Corrigendum - 9 dated 21/01/2026 to CPC Tender No. BHEL/CPC/KOD/EPC AHP PKG - II/26/058

Corrigendum - 9 dated 21/01/2026 to CPC Tender No. BHEL/CPC/KOD/EPC_AHP_PKG - II/26/058 for the work of “EPC Package (Package – II) for Main Ash Handling System of Unit#3 & Unit#4 at 2x800 MW DVC Koderma TPS Phase-II, Jharkhand”.

TITLE: PLOT PLAN
 DEPT. SCALE: [Symbol]
 DRAWING NO.: PE-DG-519-100-M001
 SHEET 1 OF 1

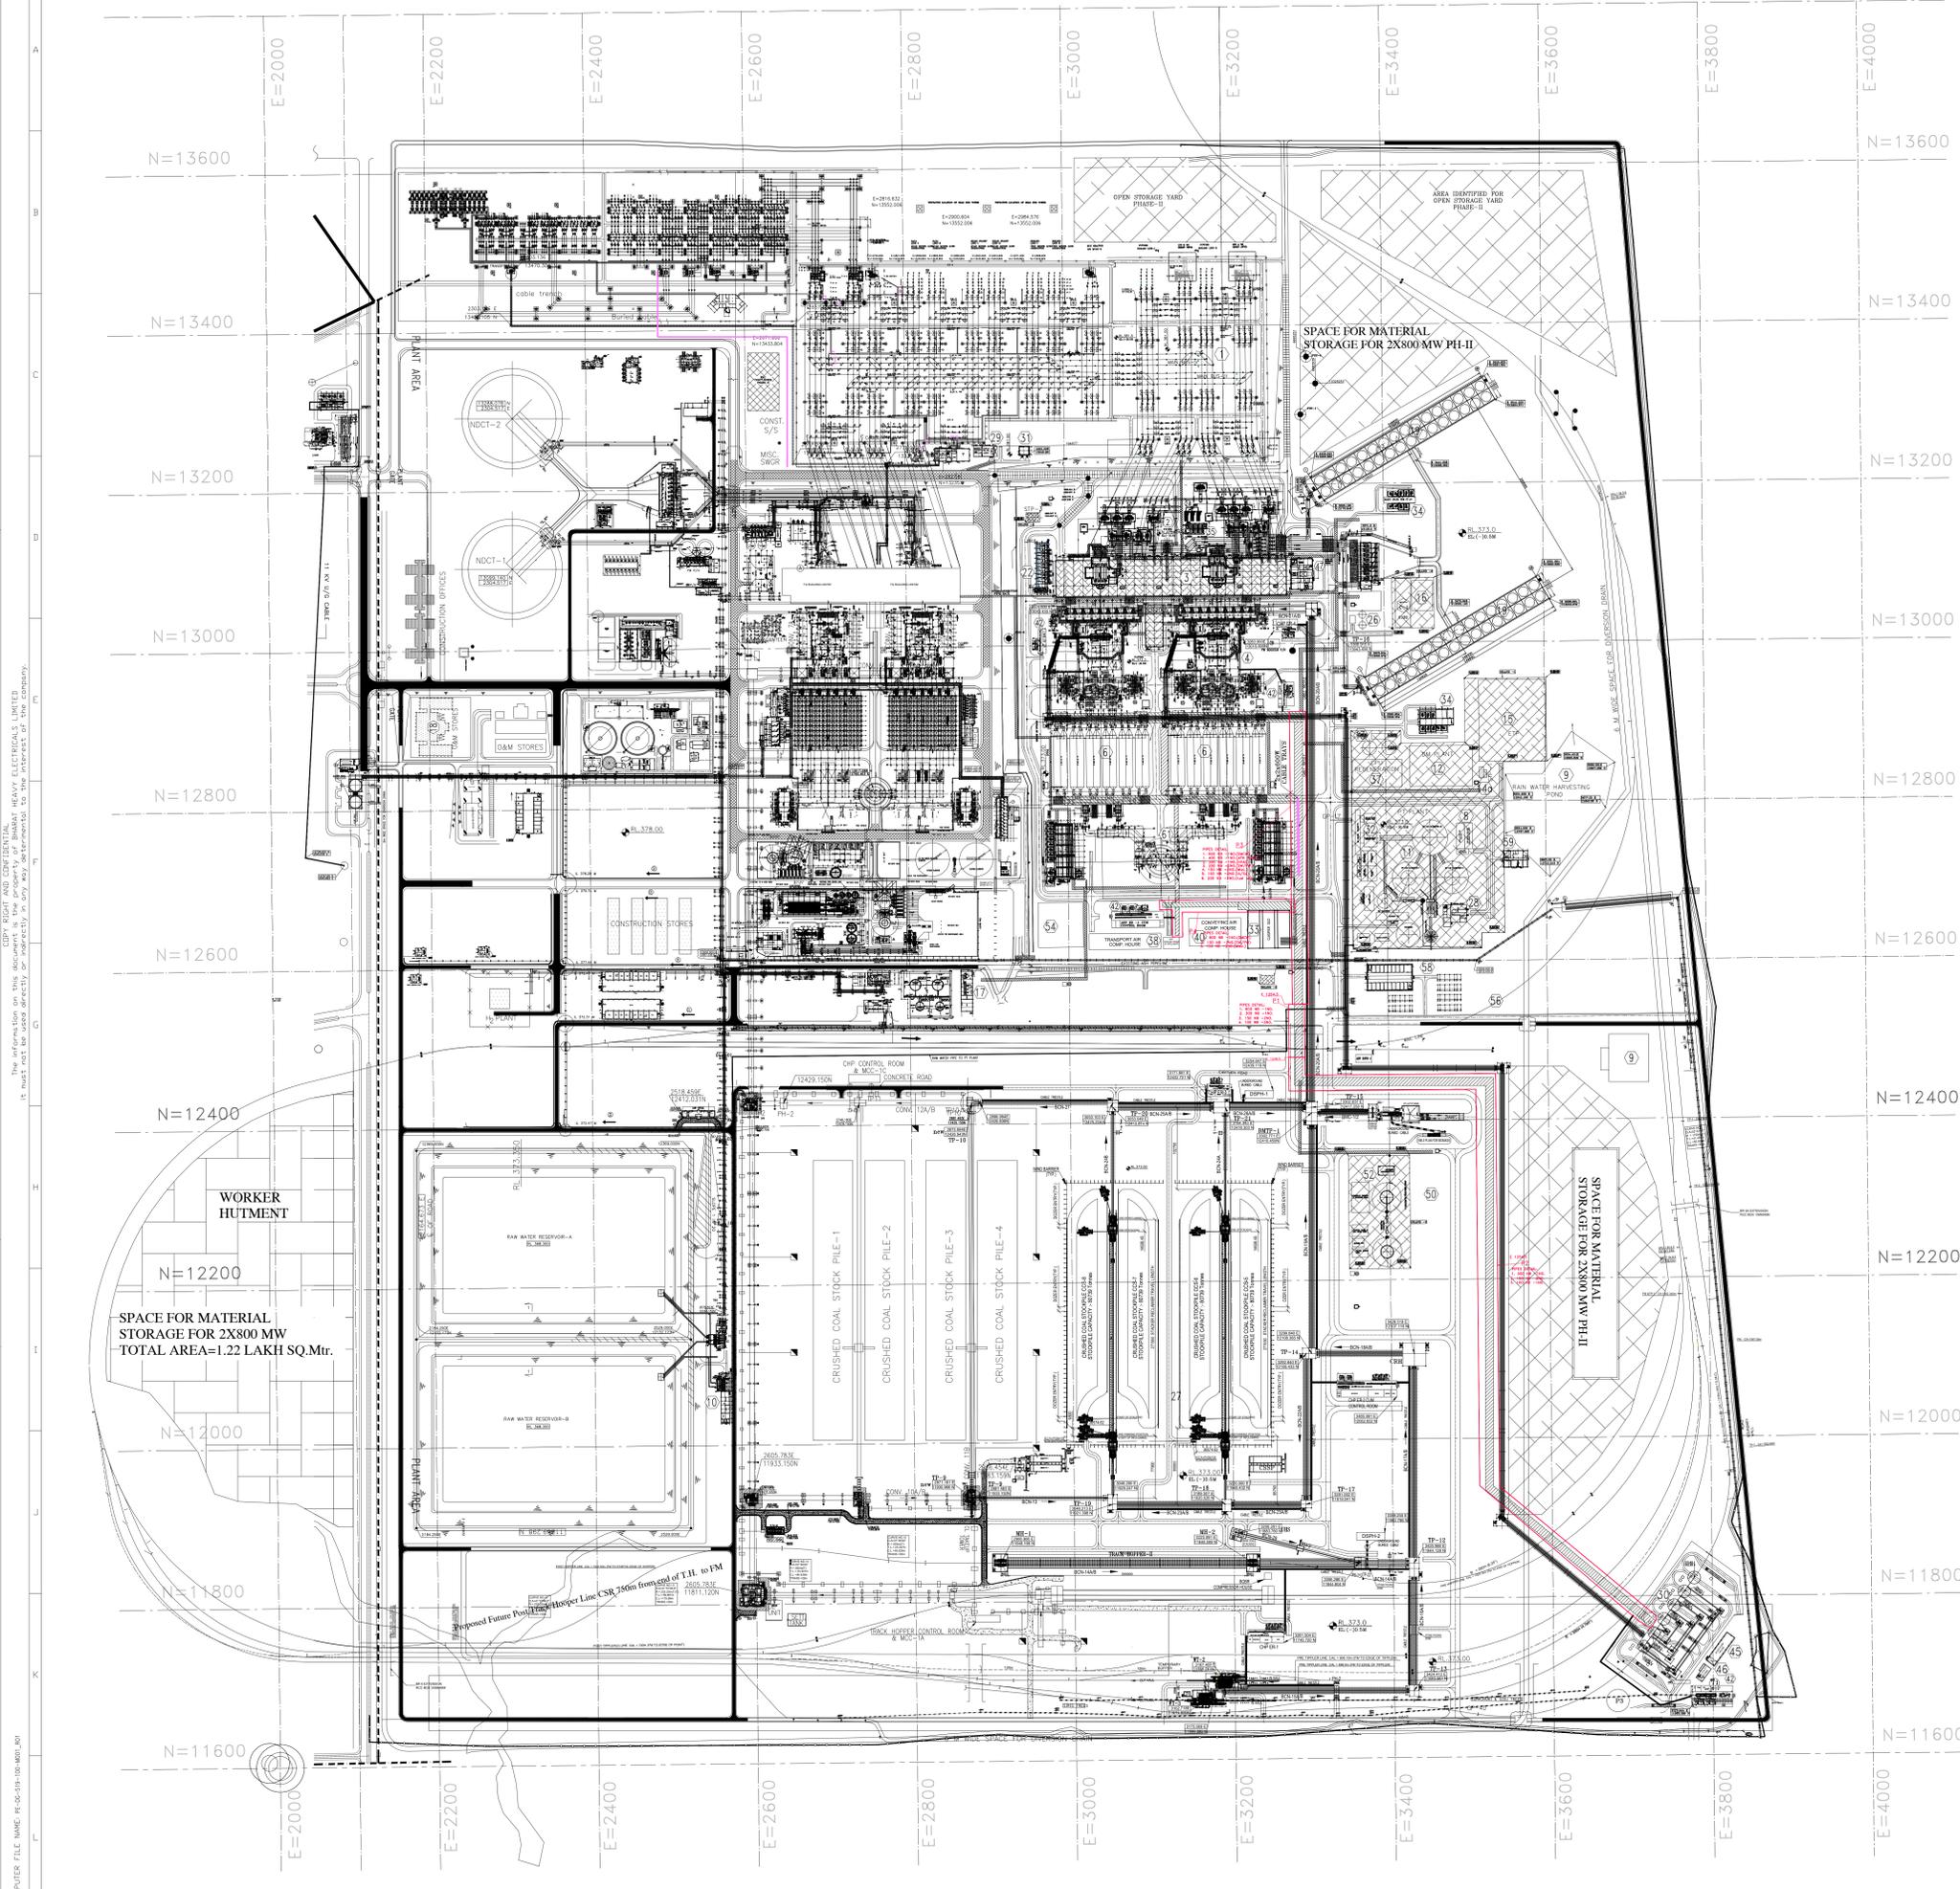
20	CHAPTER- XII: LIST OF ENCLOSURES	New Annexure Added	Annexure – 35 – Sketch for additional Pipes, Cables and cable tray on AHP Pipe Rack. The space for additional pipes and cable tray shall be provided by bidder on AHP Pipe rack in required location as marked in the sketch. Bidder to consider the same during design of Pipe Rack in detail engineering. The scope of supply and erection of this additional Pipes, Cables and Cable Tray on AHP Pipe Rack is not in bidder scope. <i>(attached along with this corrigendum)</i>
